EN 1996-1-1:2005/AC

Eurocode 6 - Design of masonry structures - Part 1-1: General rules for reinforced and unreinforced masonry structures

This corrigendum becomes effective on 29 July 2009 for incorporation in the three official language versions of the EN.

Figure 6.6 — Effective width of flanges

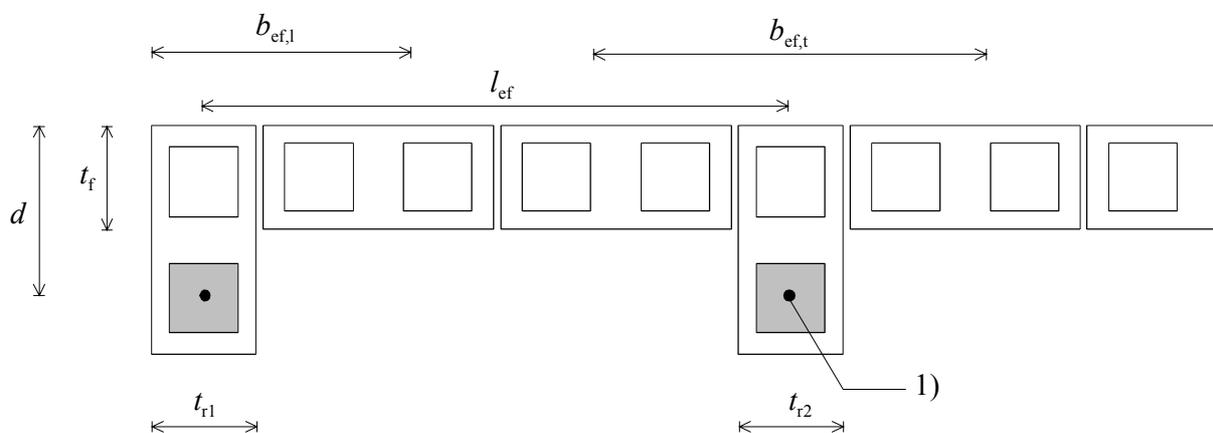
29) Modification to 6.6.3

Page 79, paragraph "(1)", replace:

$$b_{ef,l} = \text{the lesser of } \begin{cases} t_{r1} + 6 t_f \\ l_{ef} / 2 \\ h / 6 \\ \text{actual width of flange} \end{cases} \quad b_{ef,t} = \text{the lesser of } \begin{cases} t_{r2} + 12 t_f \\ l_{ef} \\ h / 3 \\ \text{actual width of flange} \end{cases}$$

- $b_{ef,l}$ effective width of a L-shaped flanged member;
- $b_{ef,t}$ effective width of a T-shaped flanged member;
- d effective depth of the member;
- h clear height of a masonry wall;
- l_{ef} effective distance between lateral restraints;
- t_f thickness of a flange;
- t_{ri} thickness of a rib, i .
